# MEMORANDUM

SUBJECT: Site Plan Approval – 1067 Marble Street, VL-1 Marble Street and VL-8 Water Street

DATE: December 28, 2023

Re: Site Plan Approval – Hale Transportation Building Addition

REVISIONS		
NUMBER	DESCRIPTION	DATE
1	CITY OF WATERTOWN COMMENTS - ADDITION OF TREE PROTECTION NOTES	12-18-2023

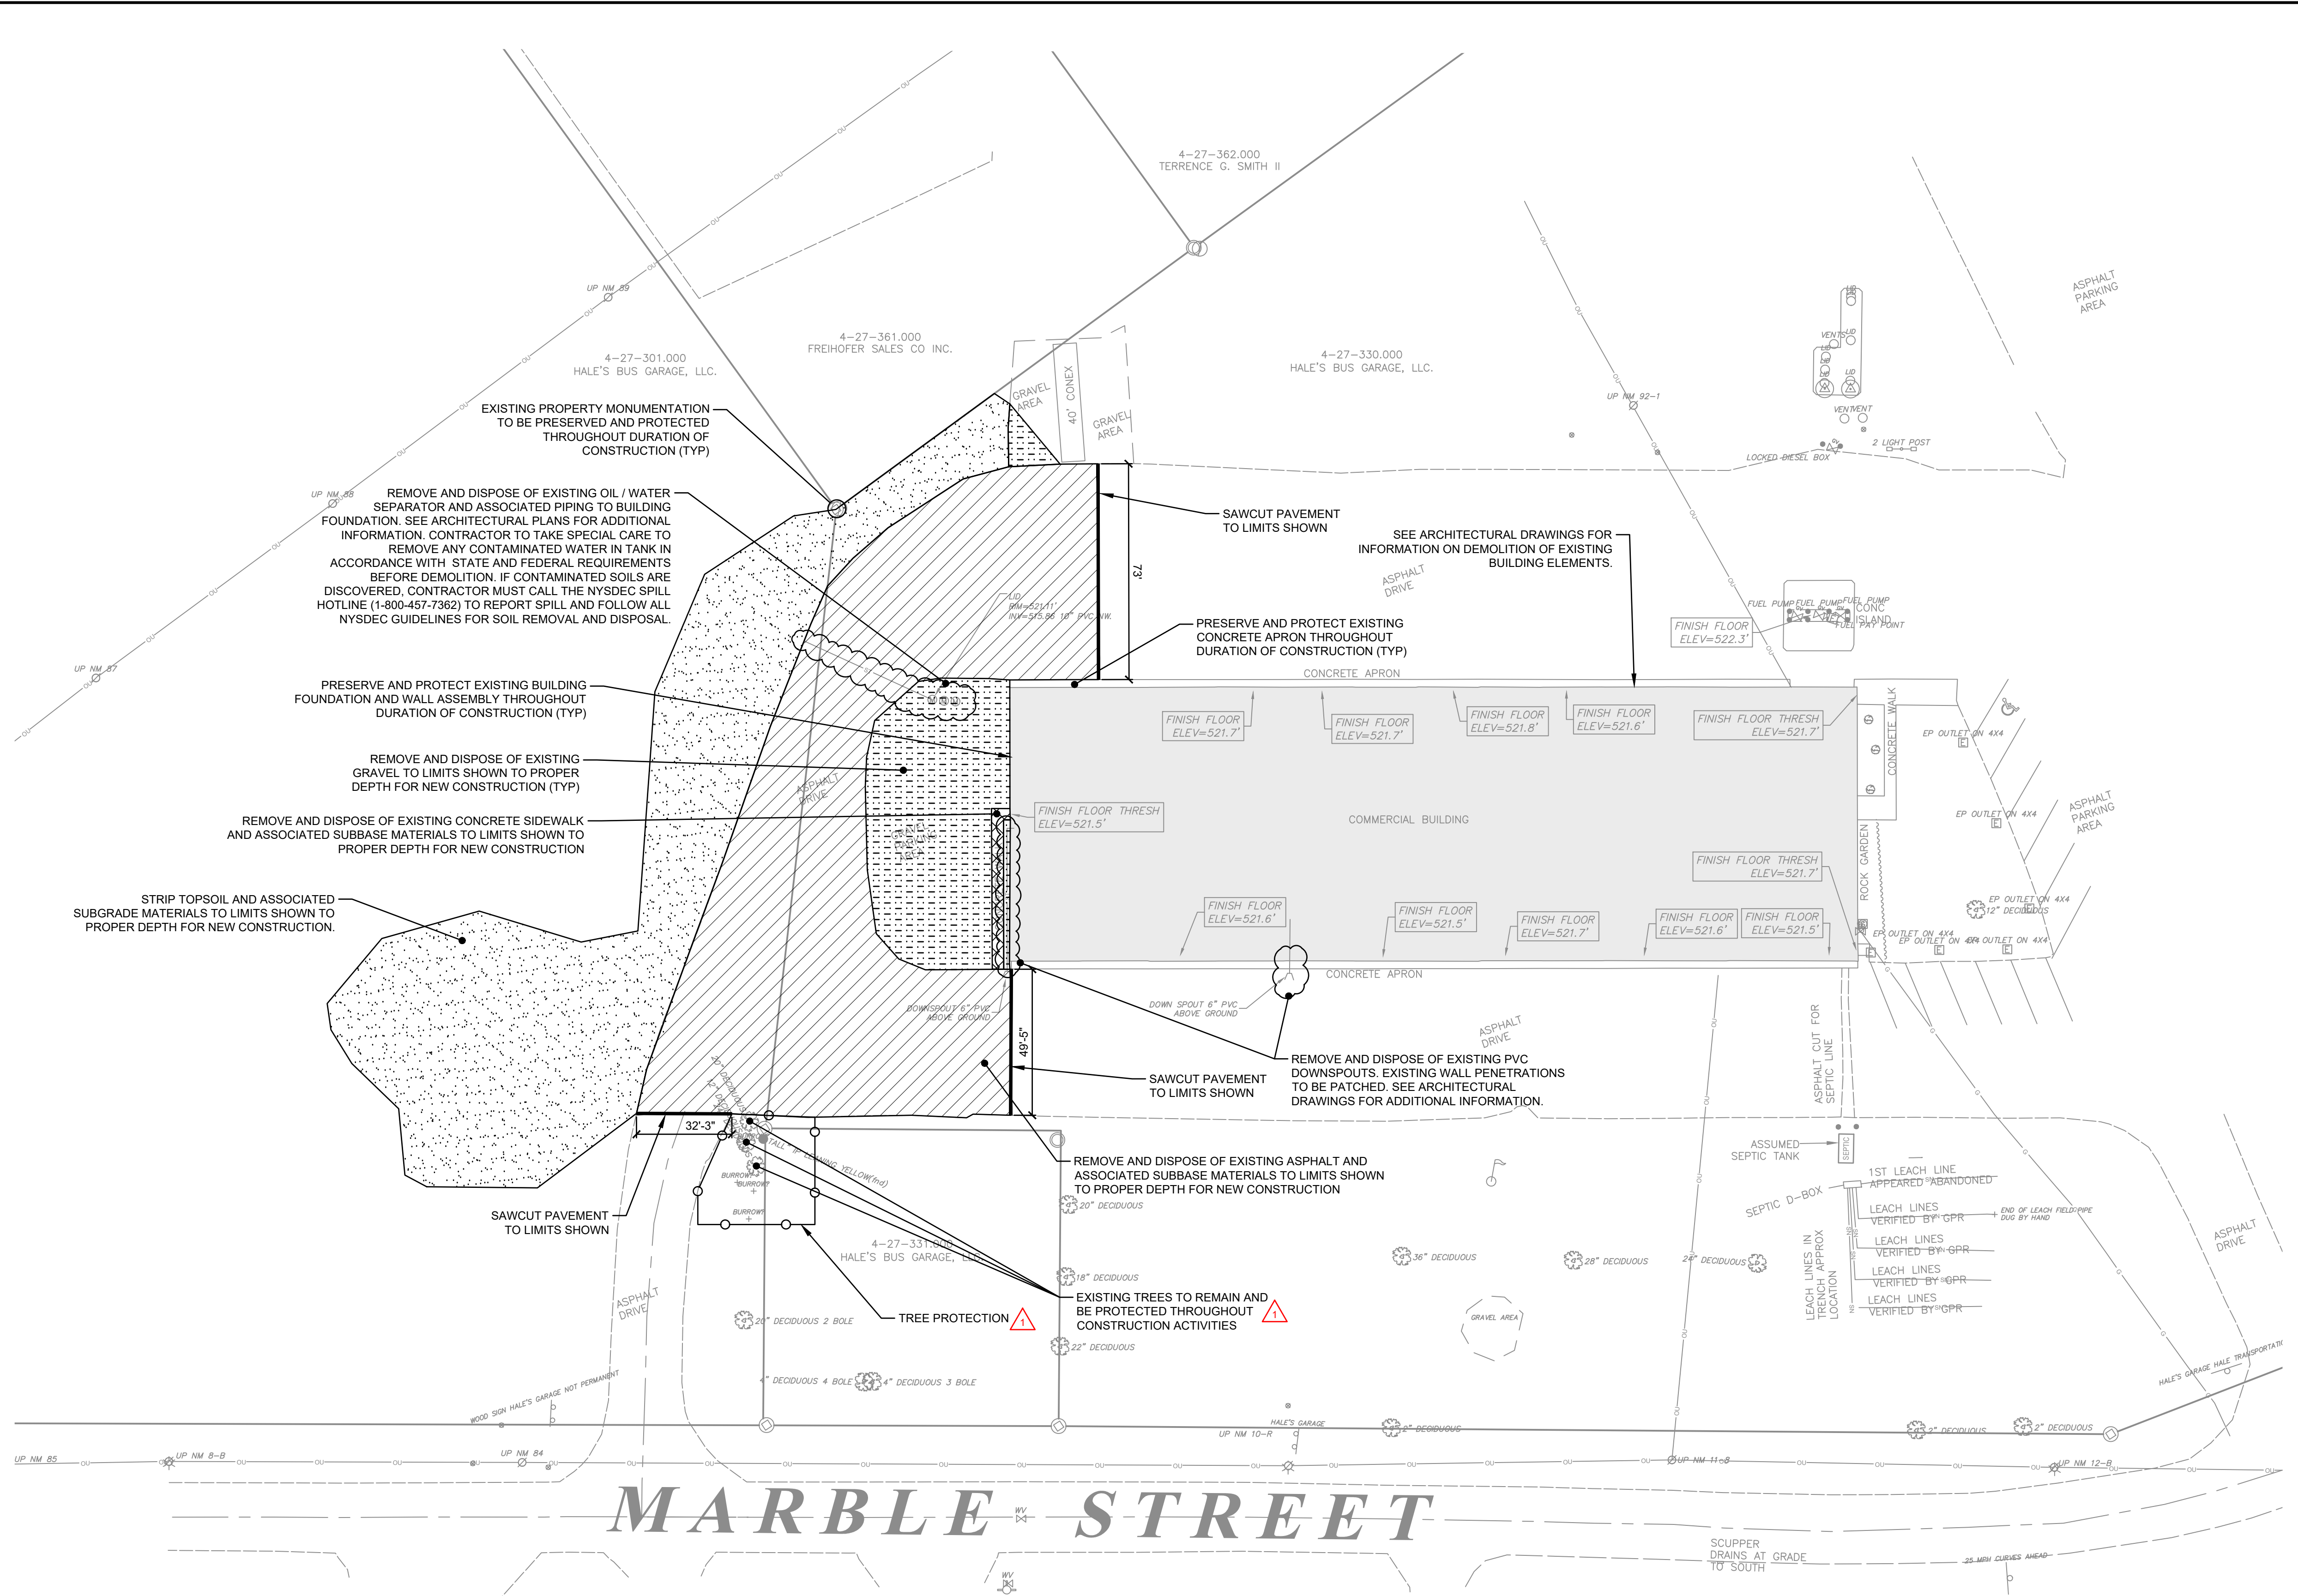
8. The applicant should establish tree protection around the existing deciduous trees adjacent to the western entrance drive and avoid parking construction vehicles or storing equipment or materials within their canopies. *This item is satisfied. The applicant has added tree protection to the Demolition Plan and a tree protection detail to the Site Detail sheet. The applicant should note that tree protection zones are most effective when communicated as a priority throughout all ranks of the construction team and installed prior to staging or storing of any project related equipment or materials.*

8. The applicant should establish tree protection around the existing deciduous trees adjacent to the western entrance drive and avoid parking construction vehicles or storing equipment or materials within their canopies.
  - a. **Tree protection has been added to the Demolition Plan, and a tree protection detail has been added to C503.**

LAST REVISED: 12-18-2023  
 FOR APPROVALS ONLY  
 NOT FOR CONSTRUCTION  
 DRAWING NO.  
**C104**

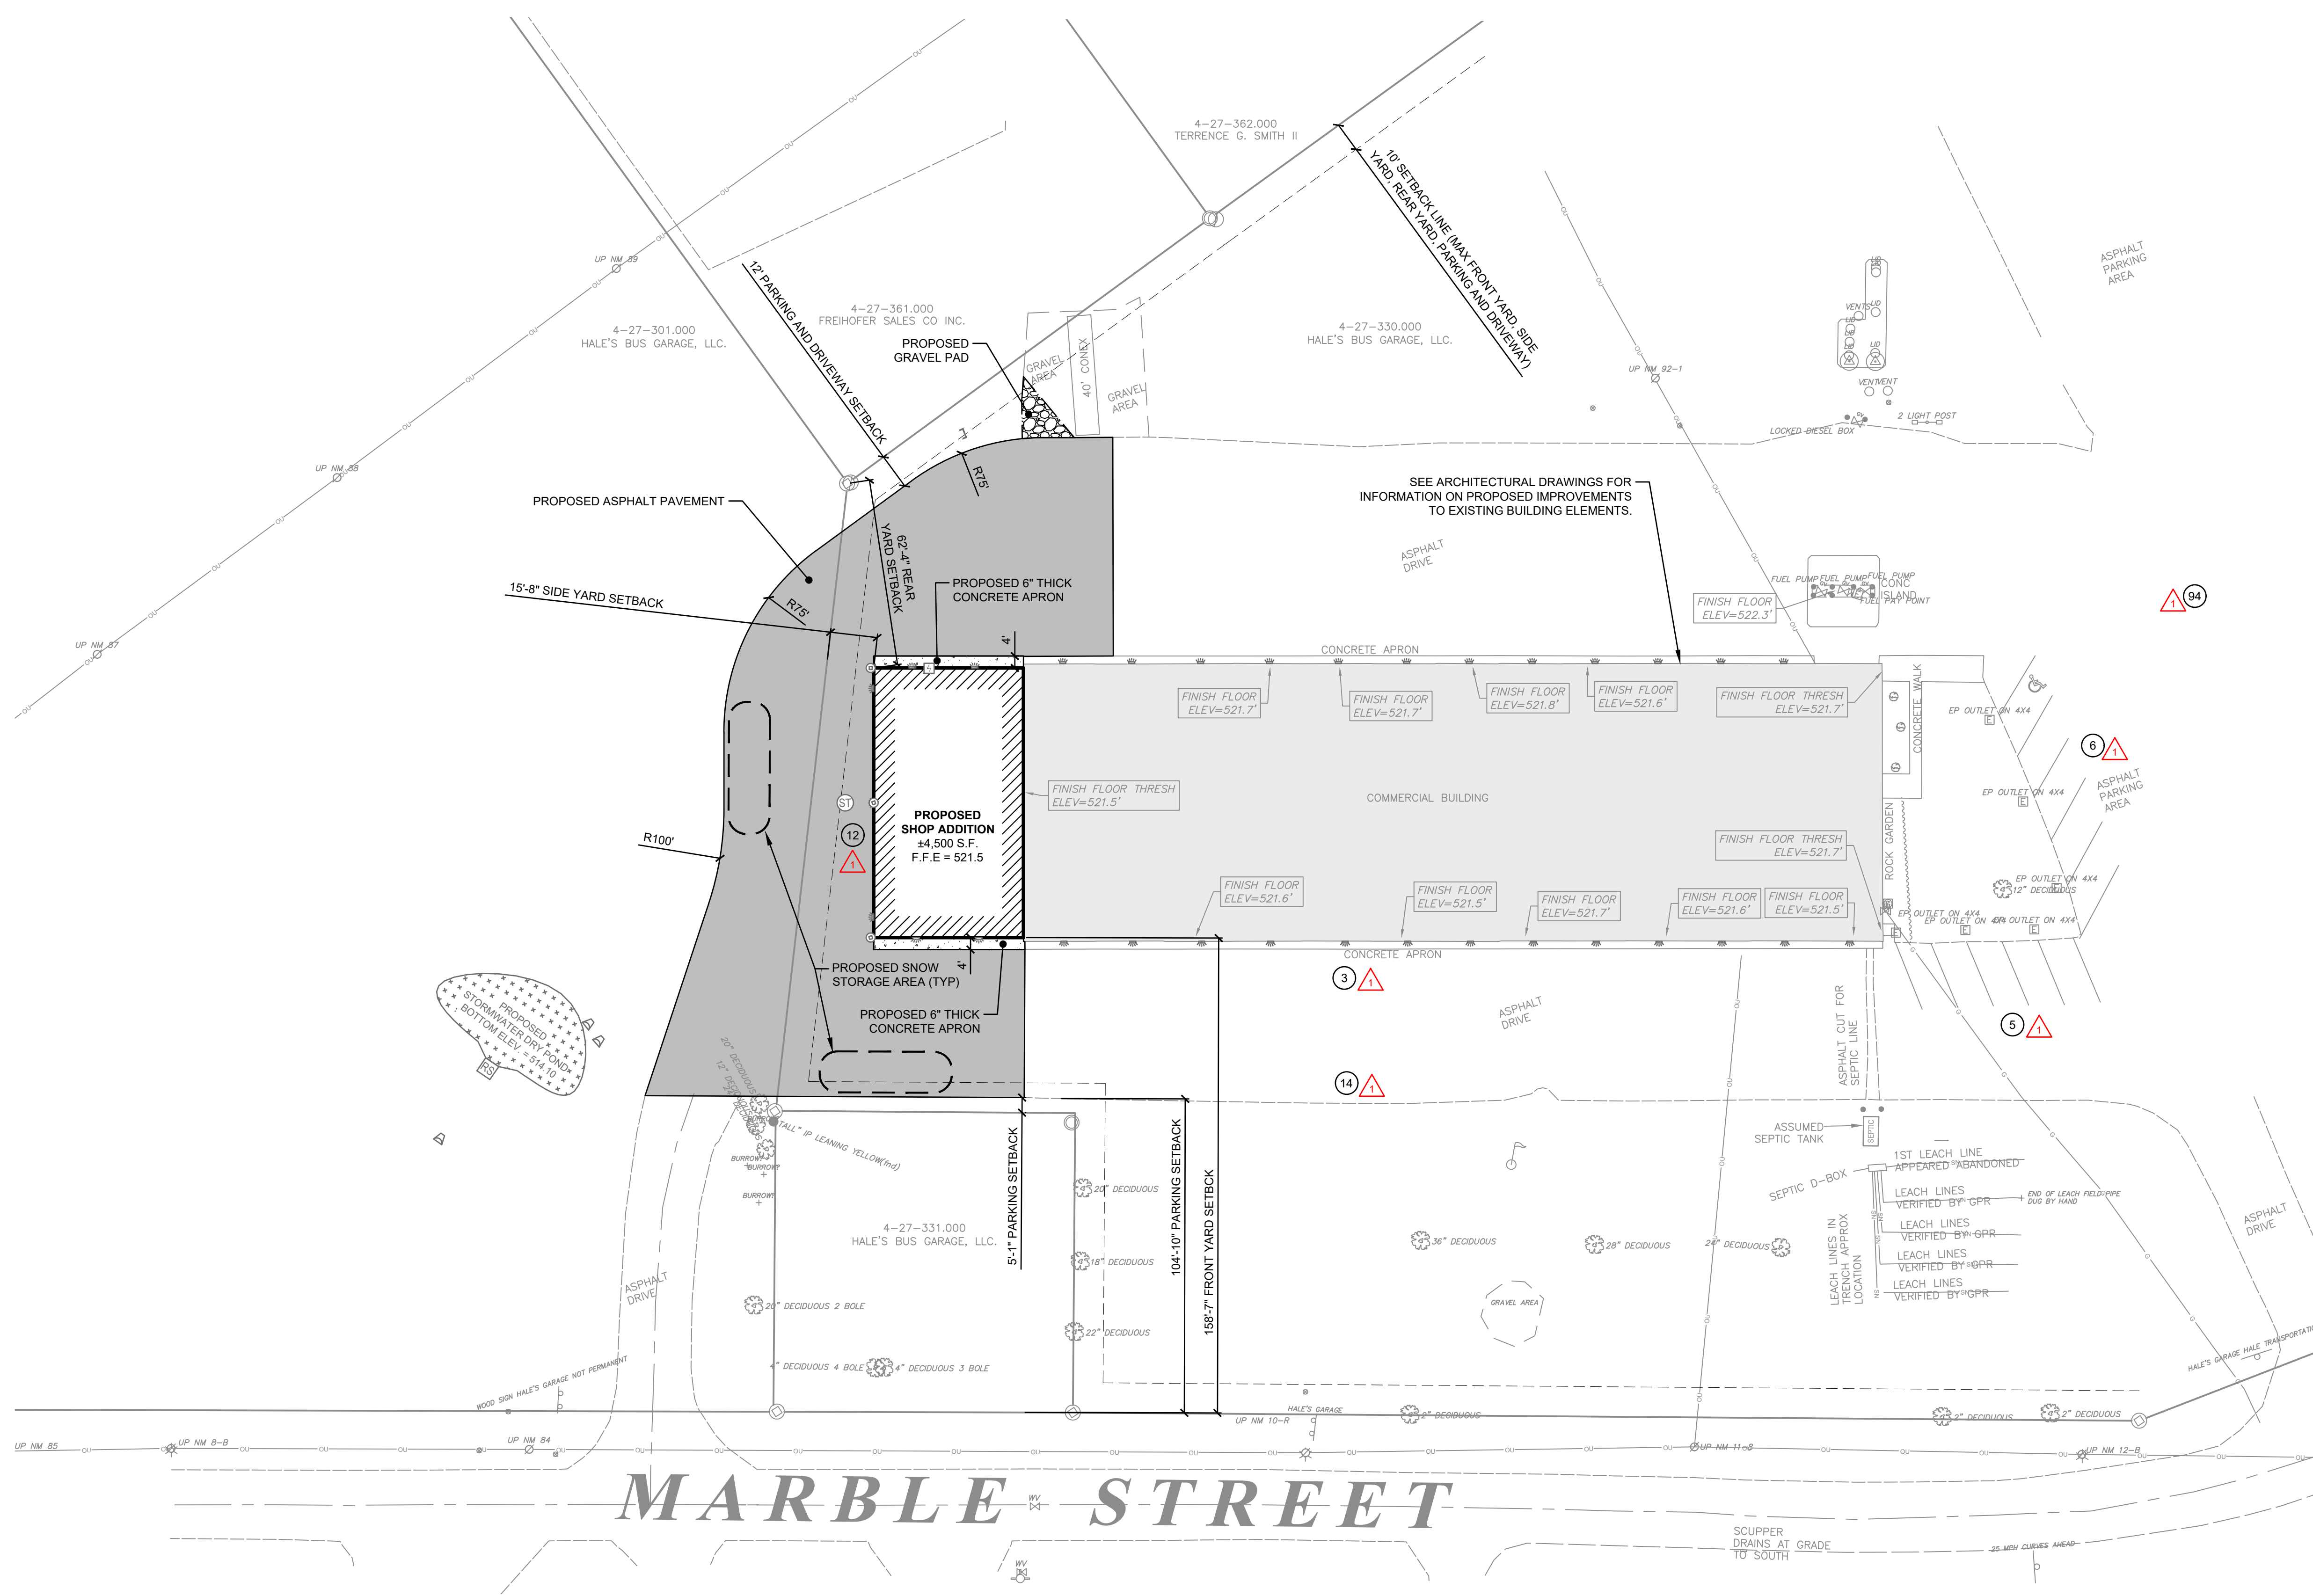
4. The applicant shall add the existing number of parking spaces on the site to the Planning Data table. *This item is satisfied. The Planning Data table on the resubmitted Site Plan drawing states that there are 134 existing parking spaces on the site. The Planning and Community Development Department will use this number on any potential future development reviews.*

**Parking:** The Neighborhood Mixed Use District allows a maximum of 16 parking spaces by right. The Planning Data table on the C104 drawing does not identify a number of existing parking spaces; only that “no new parking spaces are proposed.” It is evident from a site visit that the primary subject parcel contains well over 16 parking spaces. While the excess spaces existed prior to the adoption of the current Zoning Ordinance, and therefore enjoy legal-nonconforming (“grandfathered”) status, the applicant shall nonetheless provide a number in the Planning Data table, so that Staff can have that number on record when evaluating any potential future development on the site.

- a. **A count of the existing parking spaces and existing parking areas has been added to the Site Plan. Note that no new parking areas are proposed.**

REVISIONS		
NUMBER	DESCRIPTION	DATE
⚠	CITY OF WATERTOWN COMMENTS - ADDITION OF PARKING COUNT	12-18-2023
